**CITY OF BLOOMINGTON**

**PLAN COMMISSION**

**November 4, 2019 @ 5:30 p.m.  
COUNCIL CHAMBERS #115  
CITY HALL**

**BLOOMINGTON PLAN COMMISSION  
STAFF REPORT  
Location: 650 N. College Avenue**

PUBLIC ART ON COLLEGE

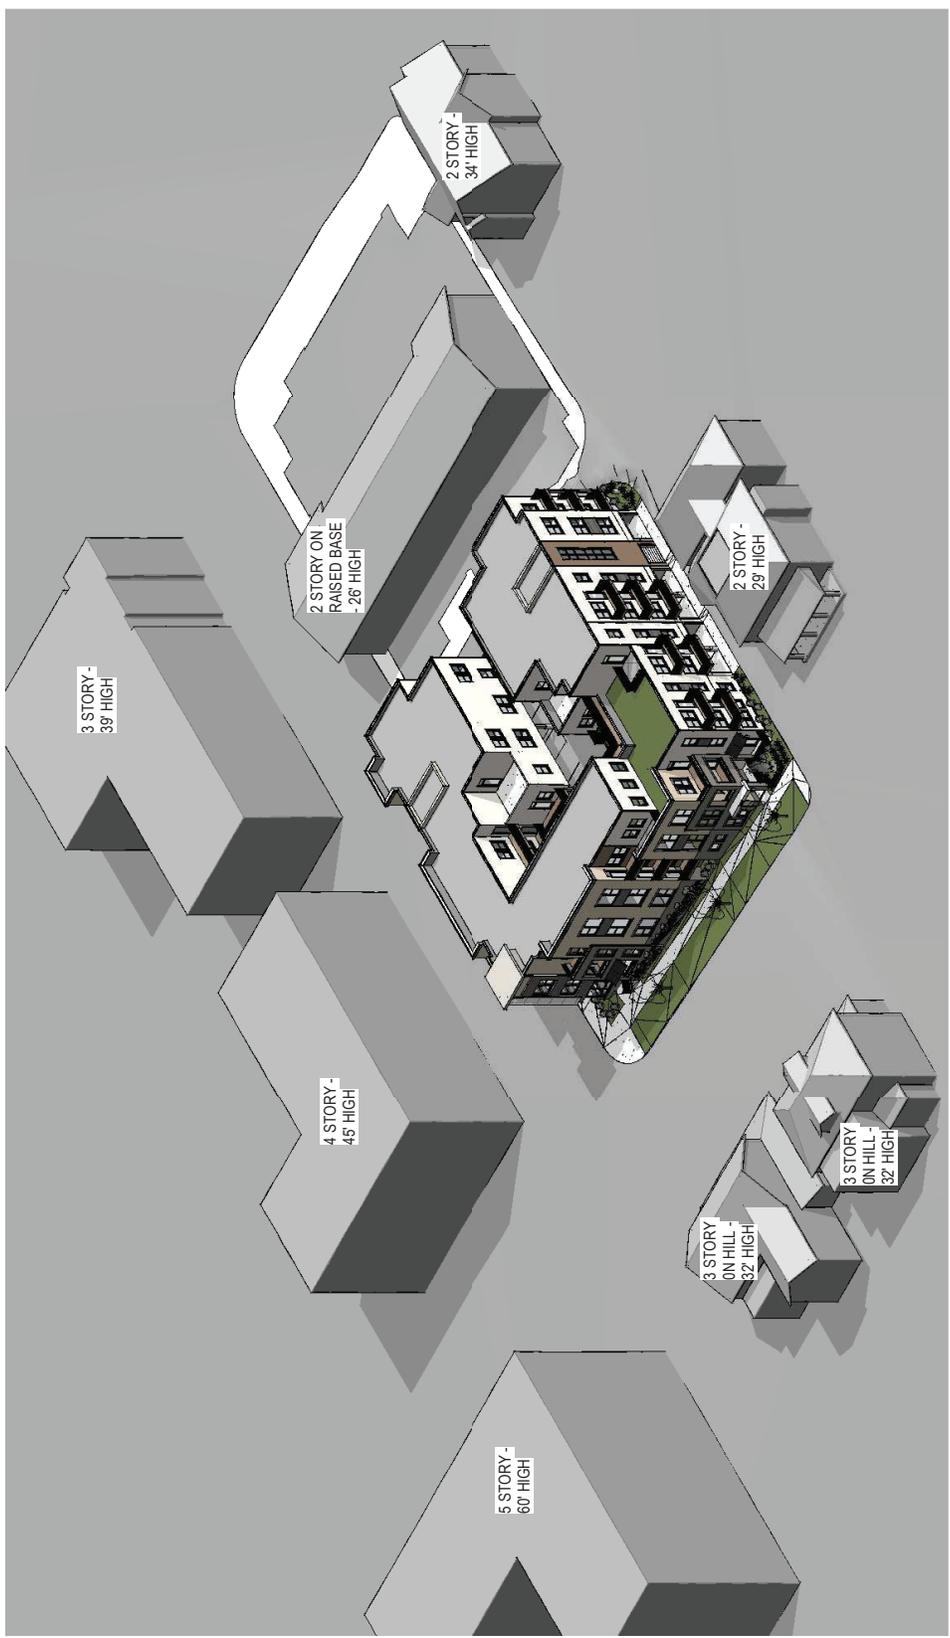
The DGO requires a void-to-solid percentage of 40% for the ground floor and 20% for the upper floor. Due to the change in grade along the College Avenue frontage there will be sections of exterior that are a solid wall. The petitioner has shown art work along this section to improve the view of the blank wall.

**20.03.340 Void-to-Solid Ratio:** An approval of deviation from the minimum required void-to-solid ratio is required for a portion of the façade along College Avenue. The DGO requires a minimum of 40% of void-to-solid along the first floor. Due to the change in grade along College Avenue and the lack of any residences or improvements behind a portion of a proposed blank wall, the building will not be able to meet the void-to-solid ratio along a portion of College Avenue. Due to the small section of wall that prevents this façade from meeting the requirement and the incorporation of artwork in this area, the Department believes the design is appropriate.

**595209**  
**C204**  
 DATE: 10/21/19  
 LANDSCAPE PLAN

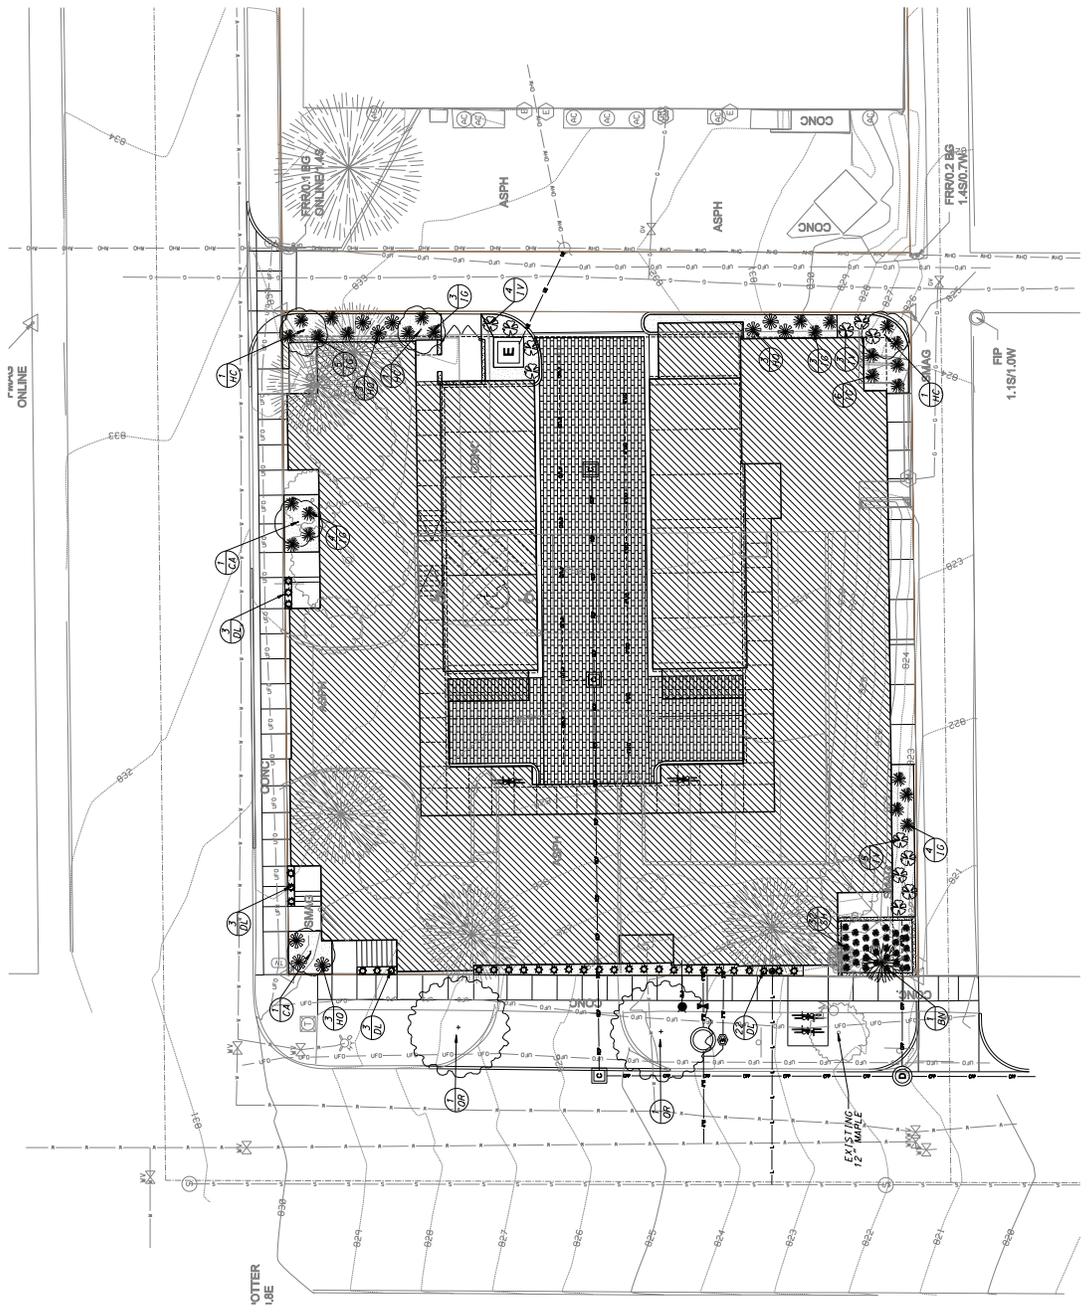
The Landscape Plan needs revision and some explanation before it meets the Unified Development Ordinance (UDO) regulations, and can be approved. The Petitioner must have an approved Landscape Plan in place prior to the issuance of the required Grading Permit. Please include additional details regarding the rain garden slopes and plants.

1.) The Petitioner shall revise the Landscape Plan to meet the minimum standards of the UDO and provide additional details regarding construction of the rain garden.

**Staff Response:** The Department will review this to insure compliance prior to issuance of a grading permit.
